# ACCESS REPORT

STATE SIGNIFICANT DEVELOPMENT APPLICATION

CLIFFBROOK CENTRE  
UNIVERSITY OF NSW

45 BEACH STREET,  
COOGEE

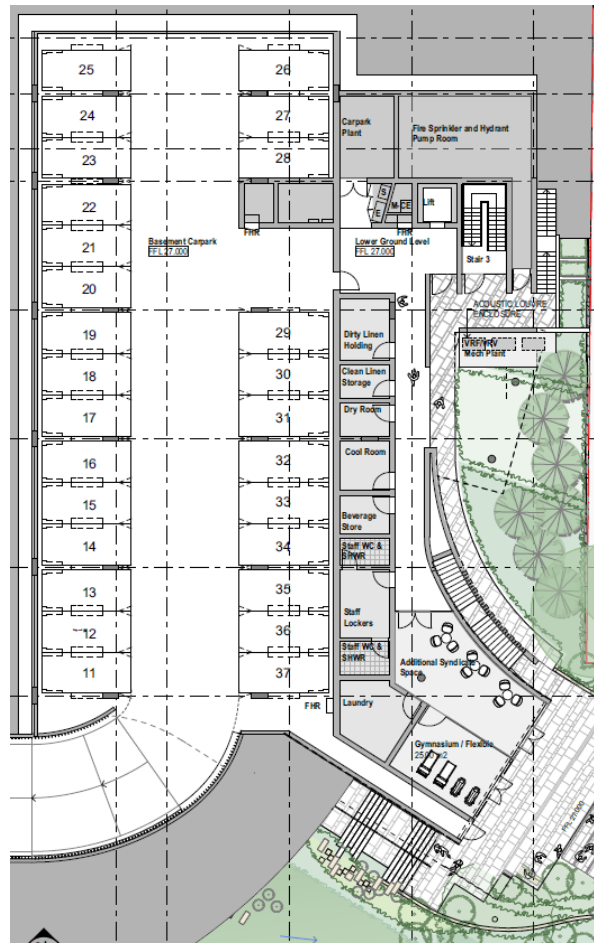
| BCA /DDA Premises Standards Review  | Complies |
|---|----------|
| 6. While the existing principal entrance has several steps the plans propose a new accessible entrance through a window being altered to be a doorway with a steel plate overlay on the northern verandah to achieve a level threshold entry which interfaces with an accessible entrance into the new Teaching Building. The new entrance shall provide a direct link to the central foyer which enables circulation | YES      |

| BCA /DDA Premises Standards Review  |  | Complies                         |
|---|--|----------------------------------|
| <p>spaces for Turning, Passing, access to doorways and the new lift that comply with ASI428.1 to satisfy Part D3.3 of the BCA and DDA Premises Standards.</p> <p>7. The new entry door shall provide an automated door opener with push button operation in a location complying with ASI428.1 to ensure equitable access.</p>  |  | YES                              |

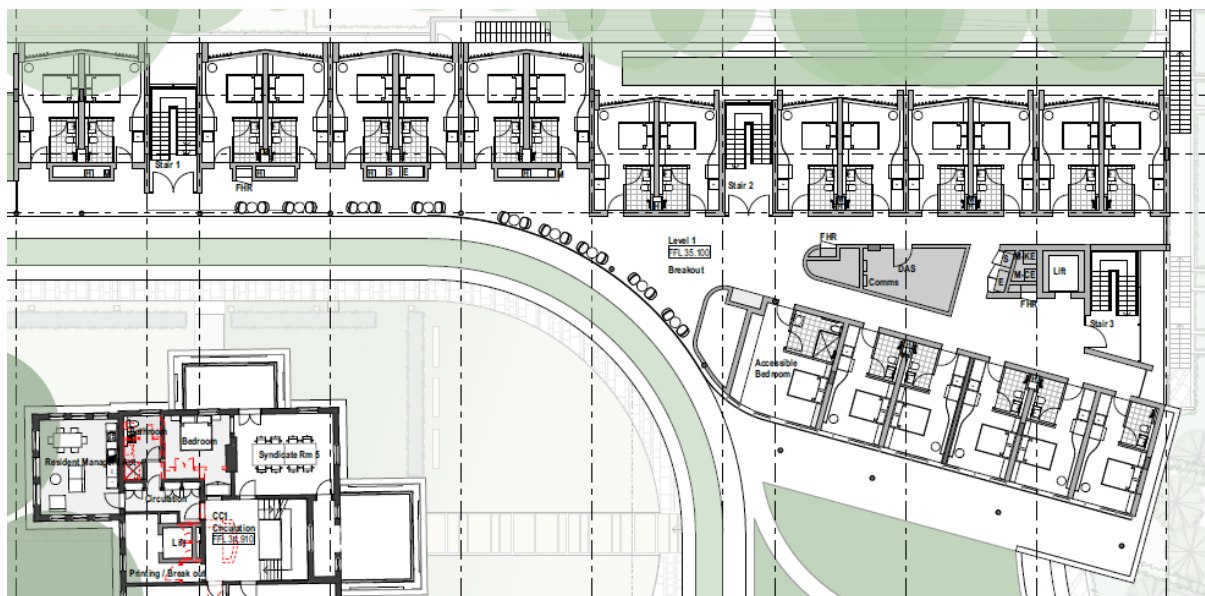
| BCA /DDA Premises Standards Review  |  | Complies                         |
|---|--|----------------------------------|
| <p>8. The double doorway into Syndicate Room 2 which has an interconnecting doorway to the adjoining Syndicate Room 1 and provides ample circulation space and width to enter the rooms in accordance with ASI428.1 to satisfy Part D3.3 of the BCA and DDA Premises Standards.</p> <p>9. The doorway to enter the Business Syndicate Room and Syndicate Room, 1 and the Officer shall be reverse hinged to facilitate enhanced doorway circulation space while several doorways to the accessible toilet shall be removed to enable a clear access path.</p> <p>10. While the staff meeting room and business centre doorways have a clear width of less than 850mm, round door knobs and limited doorway circulation spaces the programming of events within the Syndicate Rooms 3 and 4 will enable appropriate access to satisfy the objective of the DDA Premises Standards and related performance requirement DPI.</p> |  | <p>YES</p> <p>YES</p> <p>YES</p> |

**Level 1 plan**

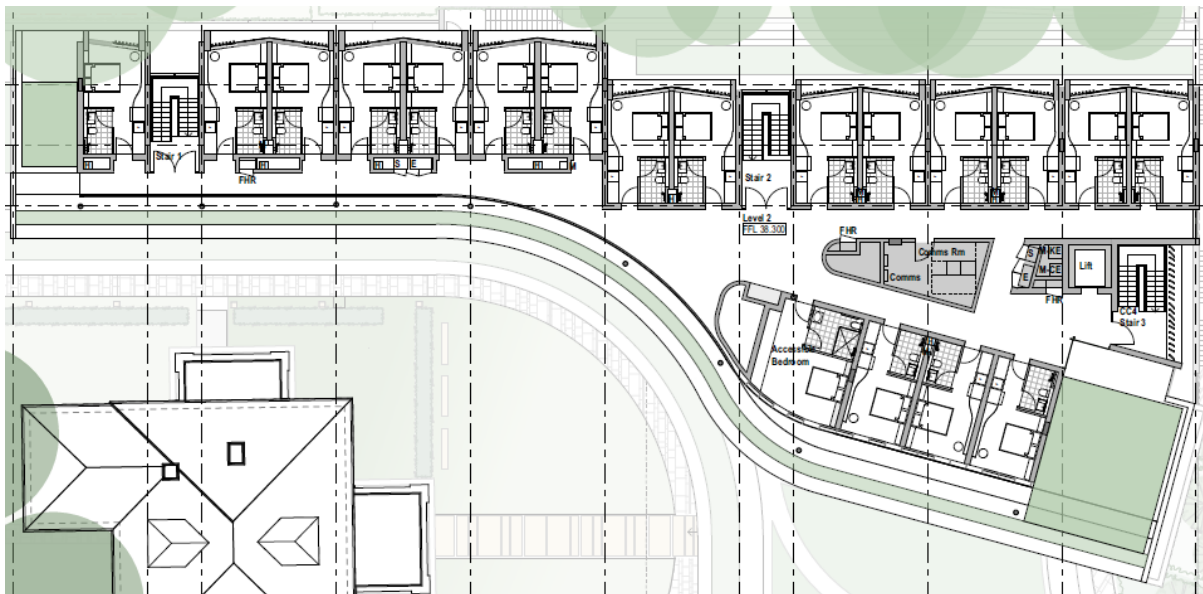
- 25. The level 1 plan of the new building proposes twenty-two (22) participant accommodation suites including one (1) accessible suite. The lift and stairs 1, 2 and 3 provide internal accessways to this level.

| BCA /DDA Premises Standards Review   | Complies          |
|--|-------------------|
| <p>26. Lift Landing &amp; Common Corridor Accessways - The 3000mm+ width lift landing and 1600mm minimum width accessways will provide accessible pathways to all areas including adequate circulation spaces for Turning and Passing in accordance with ASI428.1 to satisfy part D3.3 of the BCA and Premises Standards.</p> <p>27. Accessible Suite – See Section below regarding an internal review of the accessible suite.</p> <p>28. Cliffbrook House First Floor – please refer to the section concerning Cliffbrook House.</p> | <p><b>YES</b></p> |

**Level 2 plan (new building only)**

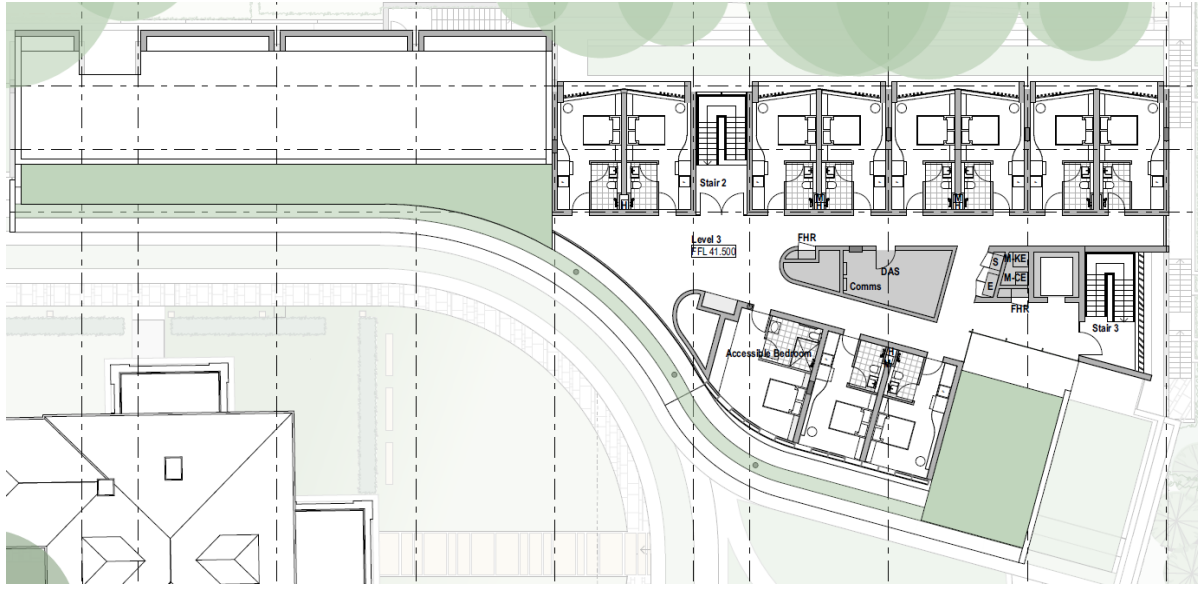
| <p>29. The level 2 plan of the new building proposes nineteen (19) participant accommodation suites including one (1) accessible suite. The lift and stairs 1, 2 and 3 provide internal accessways to this level.</p>   | <p><b>YES</b></p> |
| <p>30. Lift Landing &amp; Common Corridor Accessways - The 3000mm+ width lift landing and 1600mm minimum width accessways will provide accessible pathways to all areas including adequate circulation spaces for Turning and Passing in accordance with ASI428.1 to satisfy part D3.3 of the BCA and Premises Standards.</p> | <p><b>YES</b></p> |

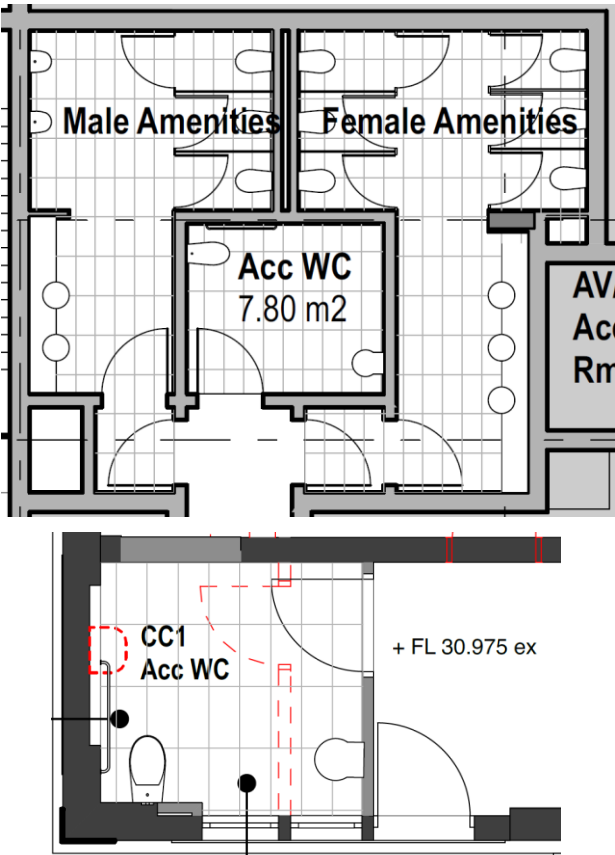
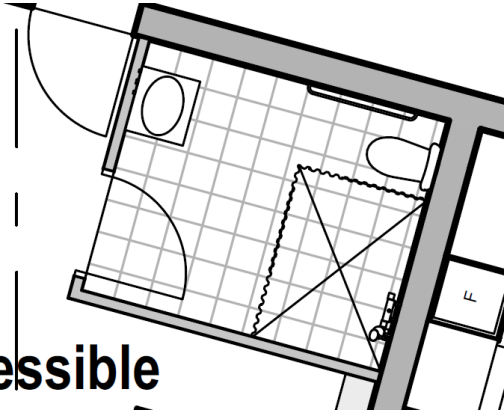
| BCA /DDA Premises Standards Review   | Complies   |
|--|--|
| <p>38. The internal layout and circulation spaces comply with ASI428.1 by providing 530mm latchside clearance at the entrance doorway and doorway circulation spaces, 1540mm X 2070mm turning area adjacent to a king size bed which also has 1000-1200mm width accessways around the three sides of the bed to comply with ASI428.1.</p> <p>39. The bathroom provides 2800mm X 2300mm area, which complies with ASI428.1.</p> |  |
| 40. Details of doors, accessible bathroom fitout, bed, joinery, accessible light switches and power points shall be confirmed at a future detailed design stage in accordance with ASI428.1 to satisfy Part D3.3 of the BCA and the DDA Access Code.   | YES can comply   |
